ADDENDUM NO. 1A

Good Shepherd Catholic Church Community Center

July 27, 2026

GRC Project 21275

1 Enlarged Plan - 1st Floor Restroom Group
SCALE: 3/8" = 1'-0"

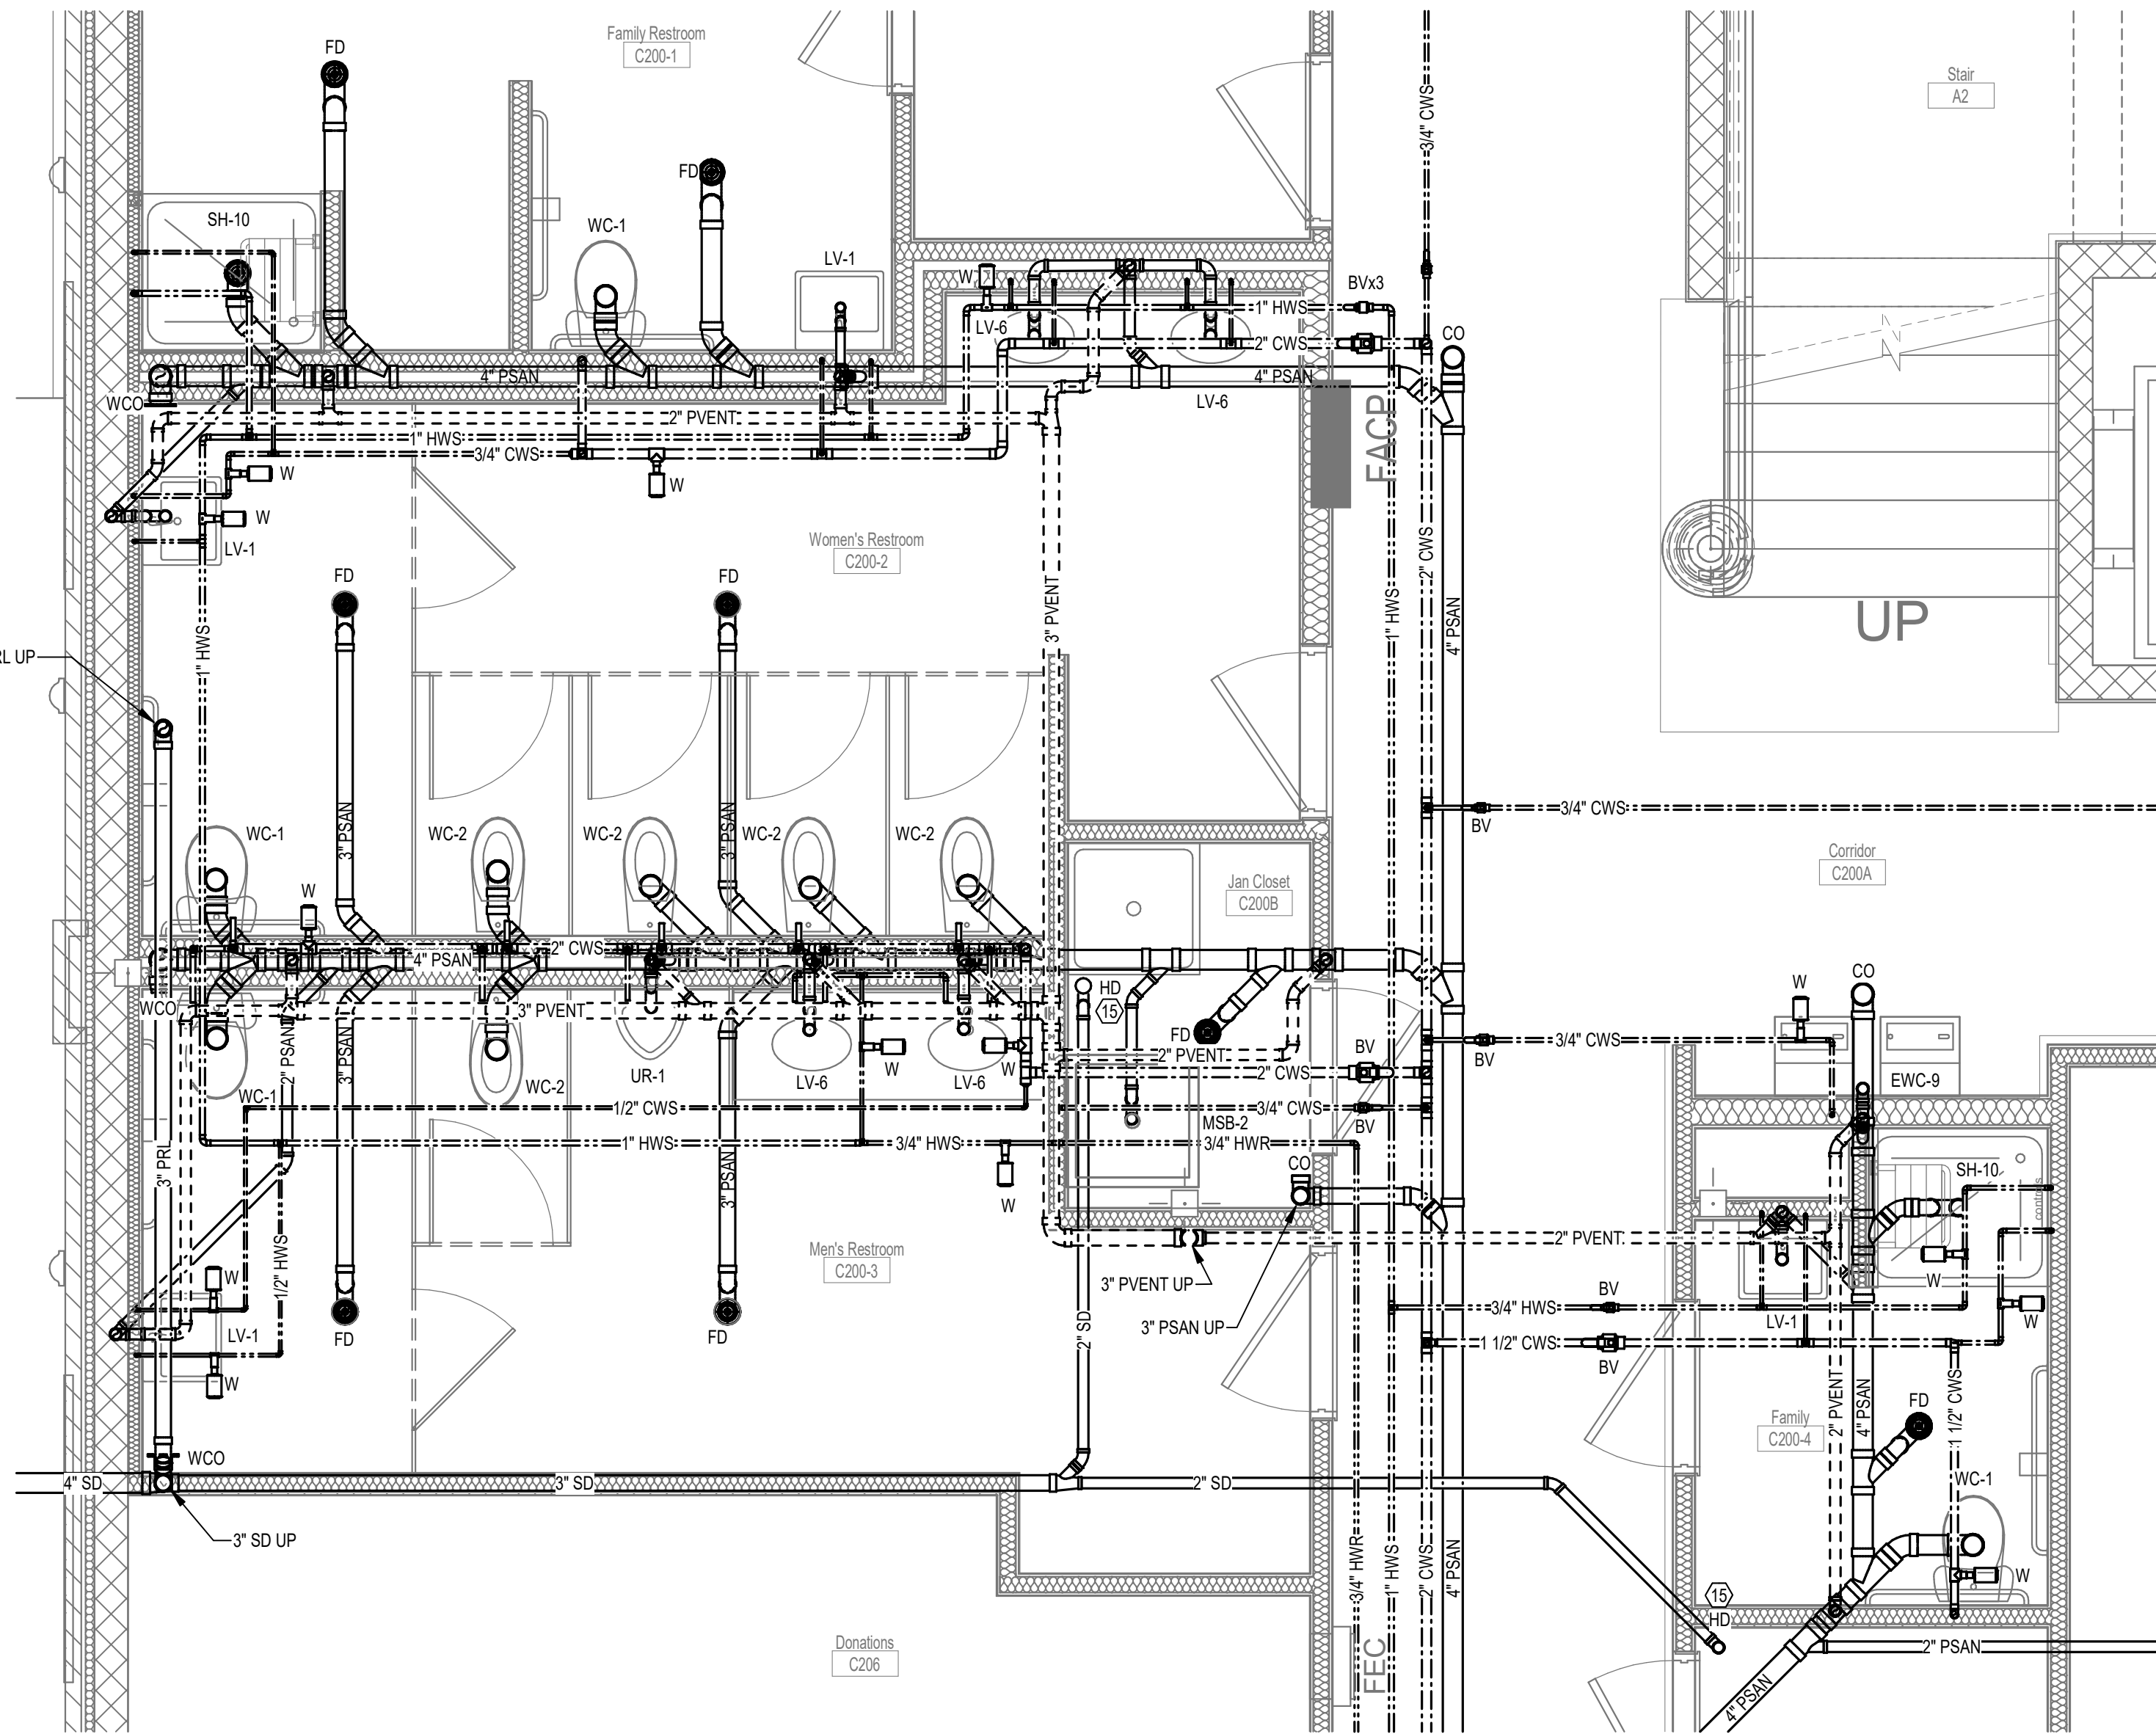
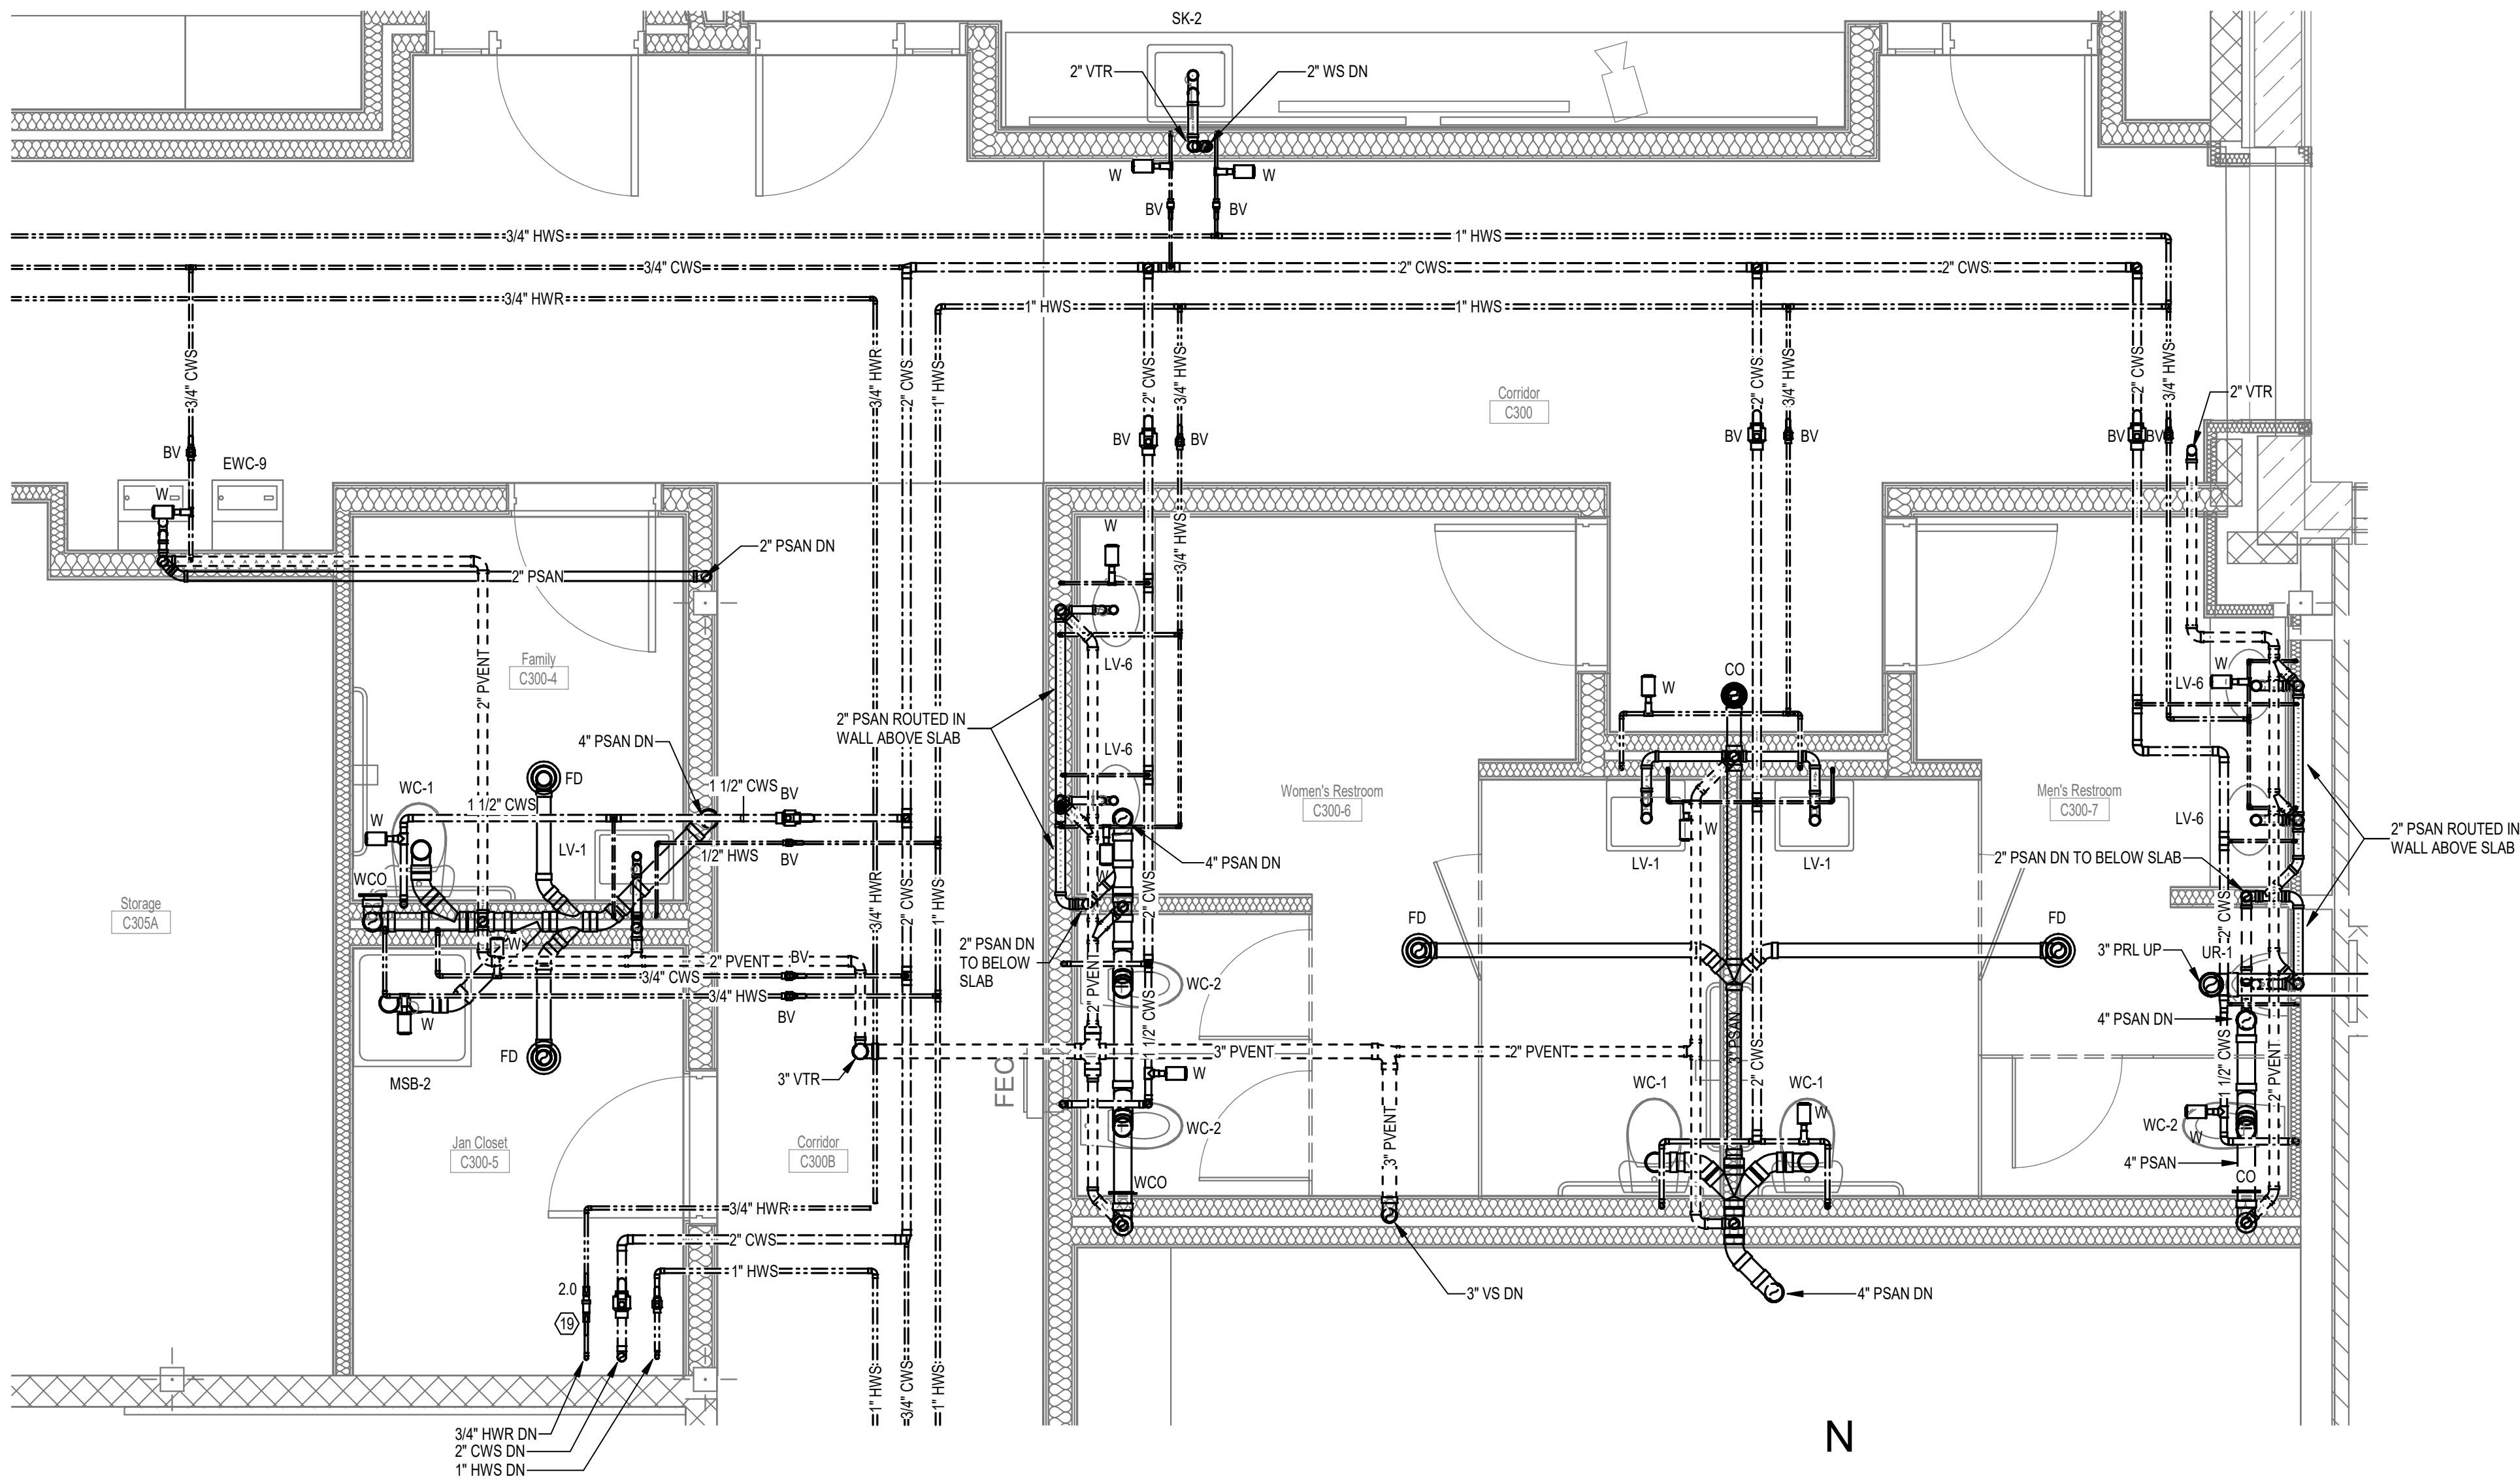
- Item P1.1.6 **Revise** overall plumbing engineering design of the following systems:
Sanitary, venting, domestic cold water supply, domestic hot water supply and return.
